### Re: DA2022/2230 – Justification Letter

We act on behalf of Tesserarch Pty Ltd (the Applicant) and have been instructed to provide a justification letter in response to Council's concerns relating to the proposed use of walls forward of the building line as addressed in Council's request for further information dated 31 March 2023.

Figure 1: Measurement of open space within front setback. Note: Measurements taken with Objective Trapeze.

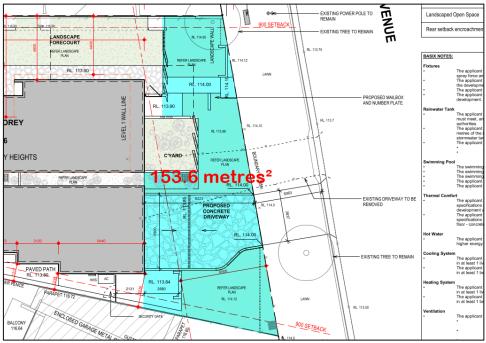
Based on the above, the proposed brick screen, walls and courtyard walls (located off the master bedroom) within the front setback area range in height from 2.0 metres to 2.4 metres. These structures result in an unreasonable bulk and scale with an adverse impact upon the streetscape. Further, these walls and screens do not facilitate the orientation of the new dwelling toward the streetscape. Rather, these walls and screens create an unreasonable separation between the dwelling and street frontage that restricts the dwelling's ability to orientate toward the street."

As it has been established that the walls are permissible and are consistent with the controls for walls forward of the building line, further consideration is given to the objectives of B7. Firstly, the development allows for a sense of openness within the front setback. The site is unique in that it is wider than longer which allows for approximately 153.6m<sup>2</sup> of open space within the front setback.

The removal of the walls will not contribute to an substantive increase to the amount of open space proposed under the current scheme. Therefore, despite the presence of the walls, the development achieves the first objective.

Figure 2: Features which identify elements that allow the development to be apparent to the street.

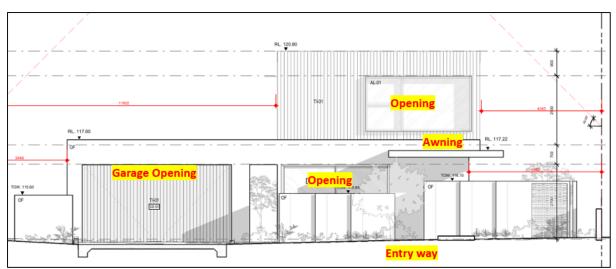
Council's letter further references the objectives of D9 Building Bulk. Council's predominant concern is that the walls create an unreasonable separation between the dwelling and street frontage that restricts the dwelling's ability to orientate toward the street.

However, the building has been orientated to present to Lanford Avenue, this is evident as the facade of the dwelling incorporates the main point of vehicular access in combination with primary openings and the use of an awning which result in the development to be apparent to the street.

Additional features also define the dwelling's ability to orientate to Lanford Avenue, these include the use of a pedestrian pathway and entry way into the property. Overall the cumulative affect these features define the front face of the buildings orientation toward Lanford Avenue and at no point do the proposed walls segregate the dwelling's ability to orientate toward the street.
